RE: Maules Creek Coal Mine – Proposed Letter Variation to Mining Operations Plan (MOP) Amendment B.

Maules Creek Coal Mine (MCCM) are writing to the Department of Regional NSW – Resources Regulator (the Regulator) to advise of a minor administrative amendment required to the MCCM Mining Operations Plan (MOP) Amendment B. Maules Creek Coal Mine has identified the need to relocate the current explosives storage compound as part of the approved MOP as per section 2.3.3 *‘during the MOP period the AN storage facility will be relocated to an area closer to the magazine facility.’*

Figure 1 – Area proposed for Explosives Compound

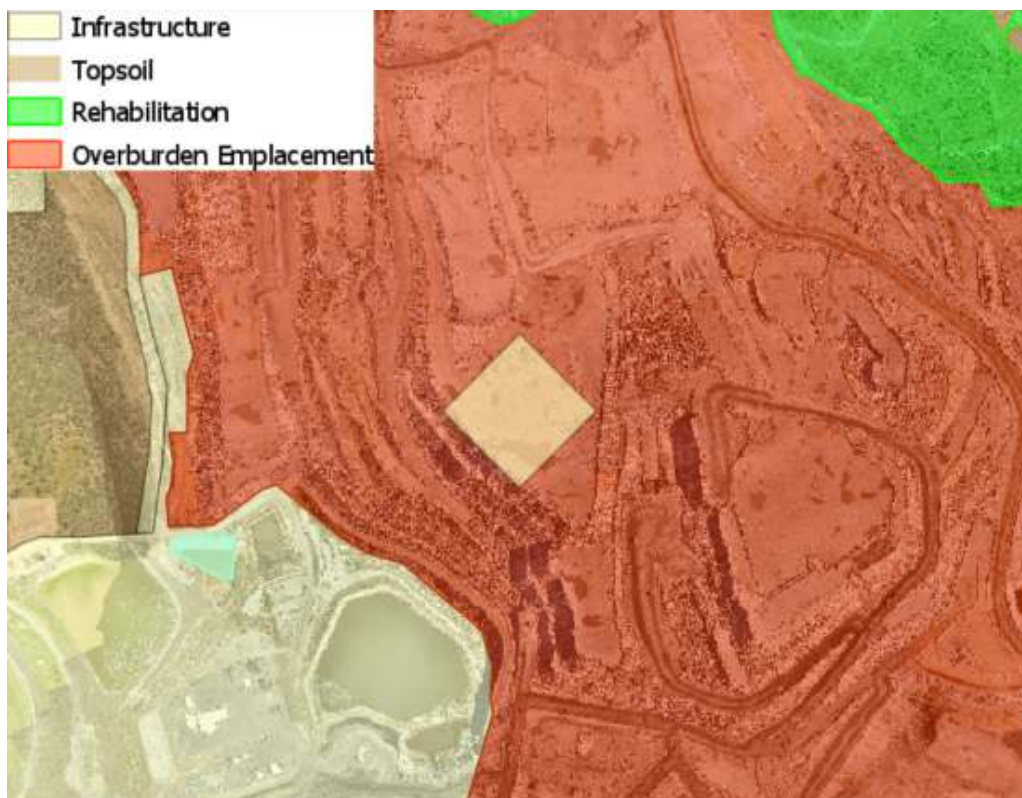
It has been identified that the preferred location for the proposed compound is within a primary domain area currently classified as ‘Overburden Emplacement’. Of this designated overburden emplacement area 7.28 ha would be required for the relocation of the compound (refer **Figure 1**). The reclassification of this area to an ‘Infrastructure’ domain will not affect progressive rehabilitation shown within MOP Amendment B.

Figure 2 – Plan 3D MCC MOP Amendment B Showing Overburden Emplacement Area (Orange Shading)

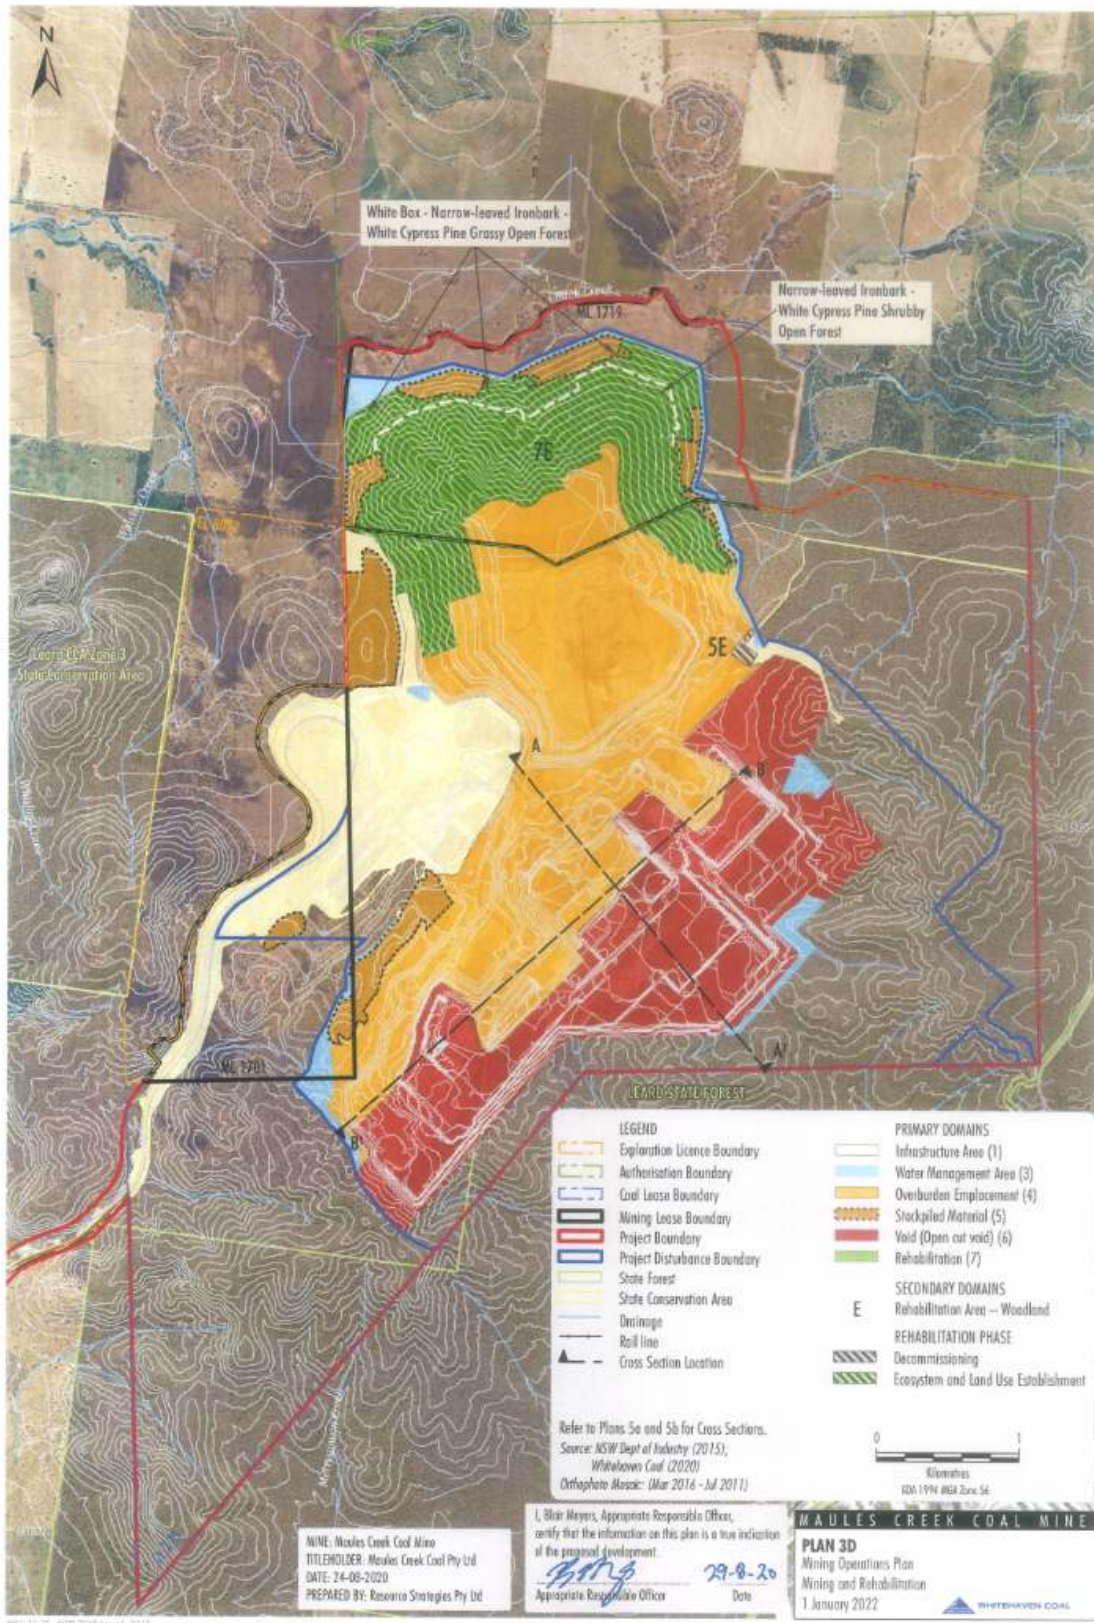
The area proposed for the explosive storage compound is not presently displayed as an 'Infrastructure' domain in the Plan 3B (refer **Figure 2** below) however, as noted above, was described in section 2.3.3 of the MCCM MOP. This minor change would require the 7.28 ha area identified in **Figure 1** to be reclassified from the overburden emplacement domain as currently displayed, to an infrastructure domain as conceptually shown in **Figure 3** and **Figure 4**.

Figure 3 – Plan showing proposed amendment to MOP domains Plan 3D

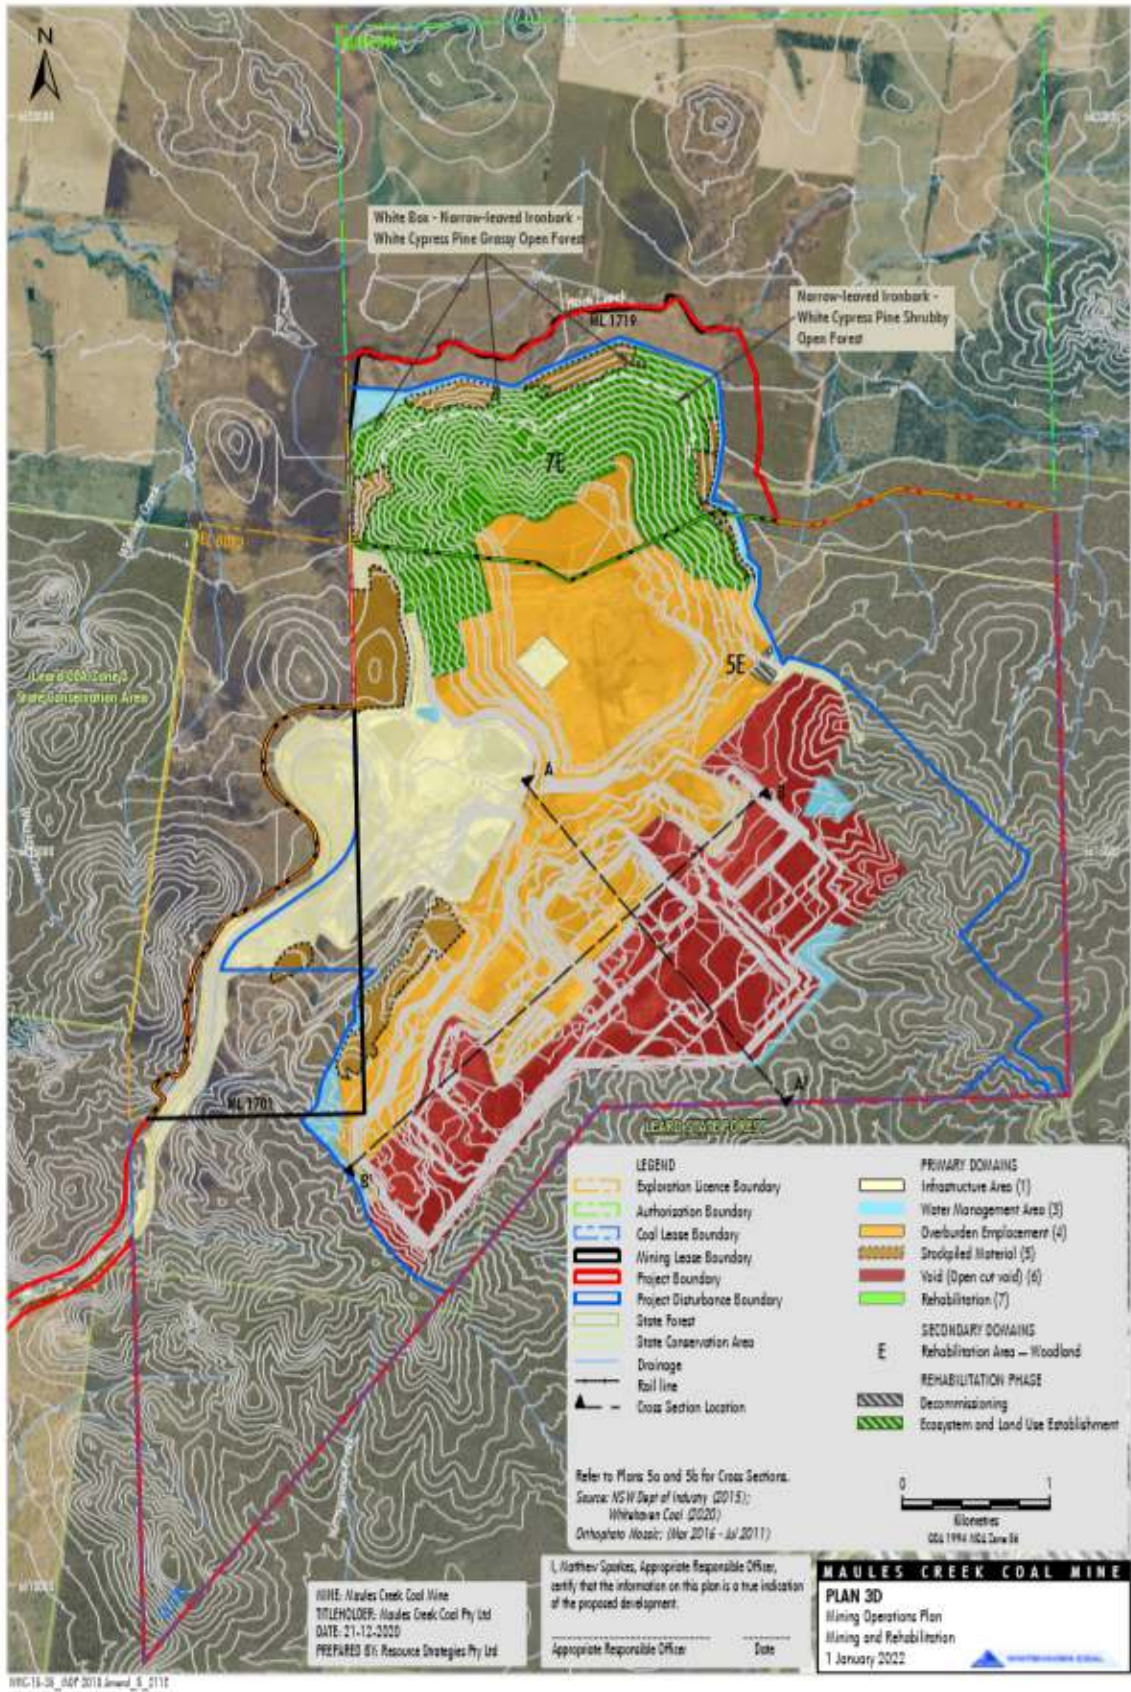
The proposed area will be situated approximately 10 meters below the final approved height (RL430) of the overburden emplacement, together with the footprint of the proposed compound and associated access road not impacting the progressive rehabilitation during the MOP term. The new location will provide a number of operational benefits including improved proximity for product delivery, greater efficiency for loading, greater distance from the site boundary for explosives security, and support continued mining and overburden emplacement on the eastern side of the lease area.
